PIC18FXX2 Rev. B5 Silicon/Data Sheet Errata

The PIC18FXX2 Rev. B5 parts you have received conform functionally to the Device Data Sheet (DS39564B), except for the anomalies described below.

The following silicon errata apply only to PIC18FXX2 devices with these Device/Revision IDs:

FIGURE 1: PINOUT DIAGRAM FOR PIC18F442/452, 44-PIN QFN PACKAGE

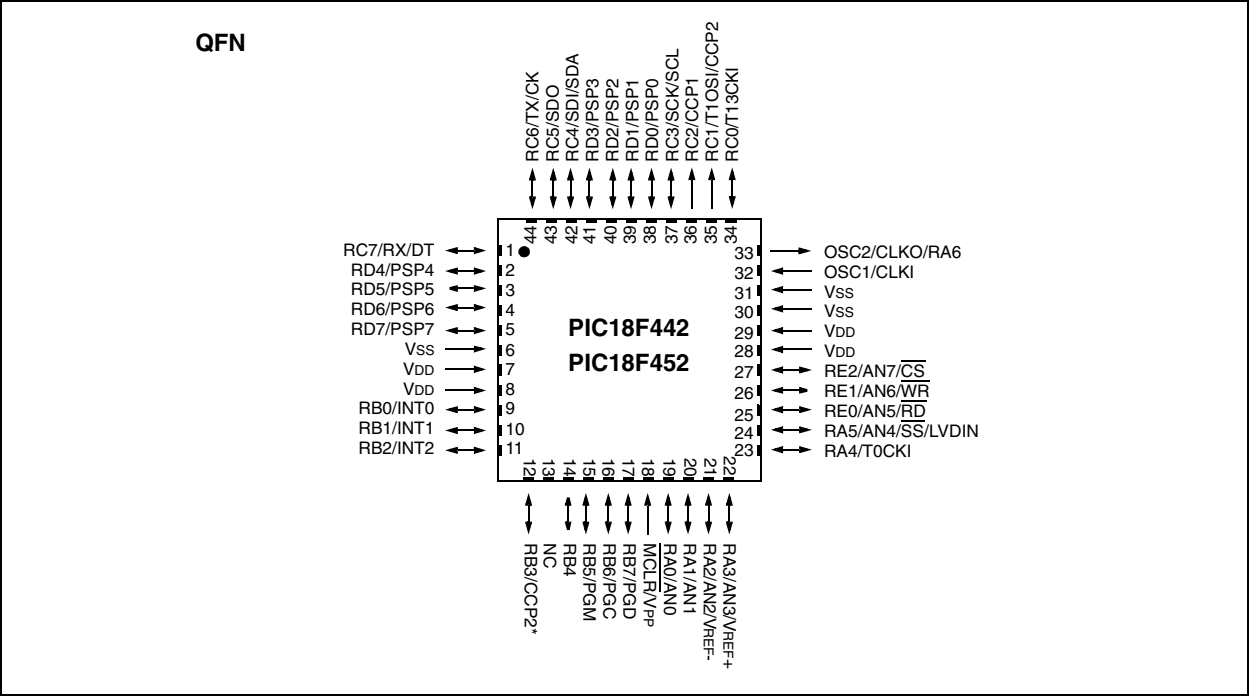
- 1. The “Pin Diagrams” on pages 2-3 of the Data Sheet are amended with the addition of the 44-pin QFN pinout, shown in Figure 1.
- 2. Table 1-3 of Section 1.0 “Overview” is replaced with an updated version which adds a column for QFN pin assignments. A row is also added for previously unlisted NC pins. All new information is indicated in **bold**.

FIGURE 3: 44-PIN QFN PACKAGE

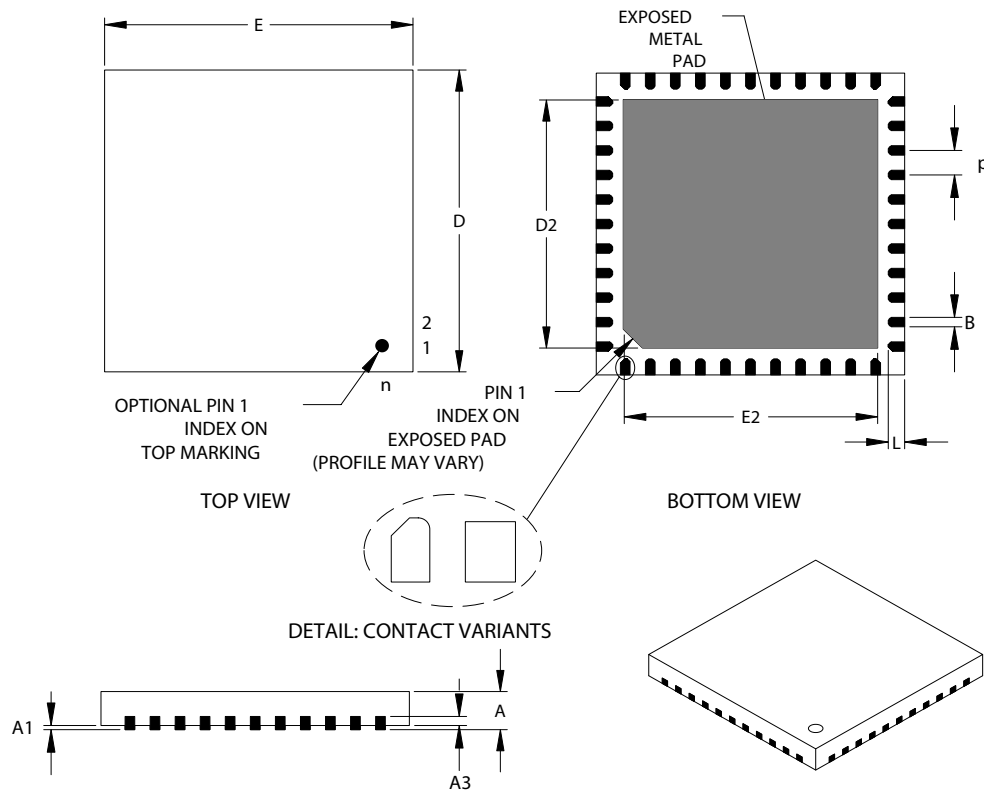
- 4. Section 24.2 “Package Details” is amended to include the mechanical drawing of the 44-pin QFN package following the existing drawings, shown in Figure 3.
